Well Name: TRIONYX 6 FEDERAL	Well Location: T25S / R32E / SEC 6 / SWSW /	County or Parish/State: LEA / NM
Well Number: 2H	Type of Well: OIL WELL	Allottee or Tribe Name:
Lease Number: NMLC061863A	Unit or CA Name:	Unit or CA Number:
US Well Number: 3002539949	Well Status: Oil Well Shut In	Operator: DEVON ENERGY PRODUCTION COMPANY LP

Notice of Intent

Type of Action: Plug and Abandonment

PLUG AND ABANDONMENT CONDITIONS OF APPROVAL

PROPOSED WELLBORE

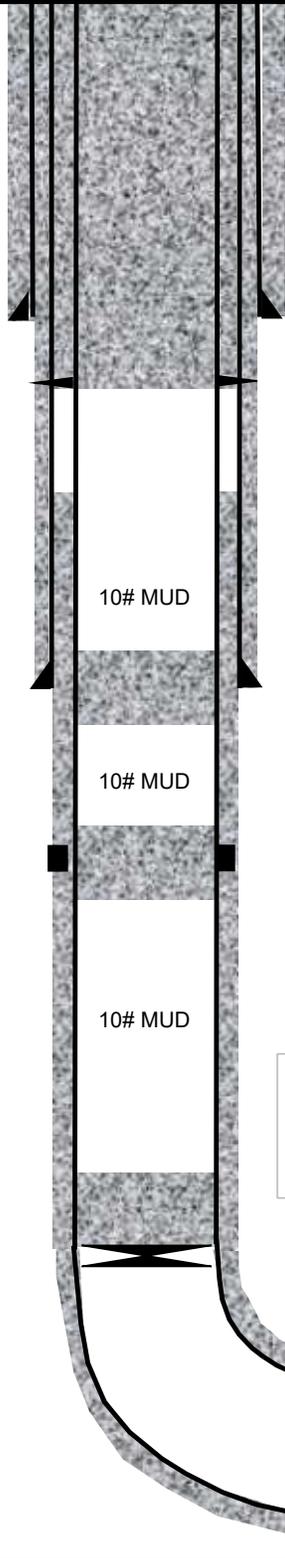
1. MIRU P&A unit. TOOH rod string and tubing from 8975'
2. Set CIBP at 8200'. Leak Test CIBP. Spot 25 sxs CL H on top.
3. Spot cement from 6015' to 5855'. WOC and Tag. 25 sxs CL C. (DV Stage Tool)
4. Spot cement from 4435' to 4063'. WOC and Tag. 37 sxs CL C. (Delaware, Shoe, Base of Salt)
5. Perf and squeeze from 1123' to surface. Verify at surface. (In 111 sxs/Out 222 sxs) CL C. (Top of Salt, Shoe, surface plug)
8. Cut WH off 3' BGL, set dry hole marker.

- No more than 3000 feet between cement plugs in cased hole.
- Wait on Cement and Tag Top of Cement Requirement:
 1. Shoe, Top of Salt, Base of Salt, DV tool, Perforate and Squeeze, Open Perforation.
 2. Formation plug is optional if a solid base is established and confirmed.

Proposed:
 1. Perf @ 1200'
 2. Pump 430 sx CI CI from 1100' to surface.
 3. Cut WH off 3' BGL, Set dry hole marker.

Proposed:
 1. Spot 35 sx CI C from 4425'-4075' WOC & Tag
 (T. Delaware @ 4385'; Shoe @ 4355'; B. Salt @ 4155')

Proposed:
 1. Spot 25 sx CI C from 6100'-5850' WOC & Tag
 (DV Tool @ 5965')

Proposed:
 1. Set CIBP @ 8200'. Tag. Circ 10# salt gel. Leak test.
 2. Spot 25 sx CI H from 8200'-8000'.
 (Perfs @ 9692'; T. Bone Spring @ 8359')
